ST/SG/AC.10/C.3/2002/6
13 March 2002

**COMMITTEE OF EXPERTS ON THE TRANSPORT OF
DANGEROUS GOODS AND ON THE GLOBALLY
HARMONIZED SYSTEM OF CLASSIFICATION
AND LABELLING OF CHEMICALS**

**Criteria for the corrosiveness of liquids and solids belonging to Class 8,
Packing Group III, for steel and aluminium**

Submitted by the expert from Germany

Fig. 1: specimen

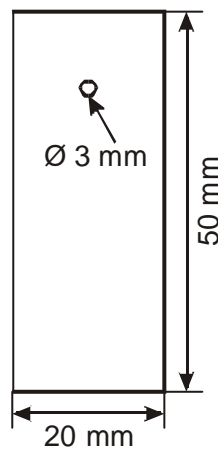
For exposure to medium being classified specimen of 2 mm thick plates shall be made of the following materials:

- Aluminium, non-clad types 7075-T6 or AZ5GU-T6 and
- Steel, S235JR+CR (1.0037 resp. St 37-2), S275J2G3+CR (1.0144 resp. St 44-3) or a similar type (Fig. 1)
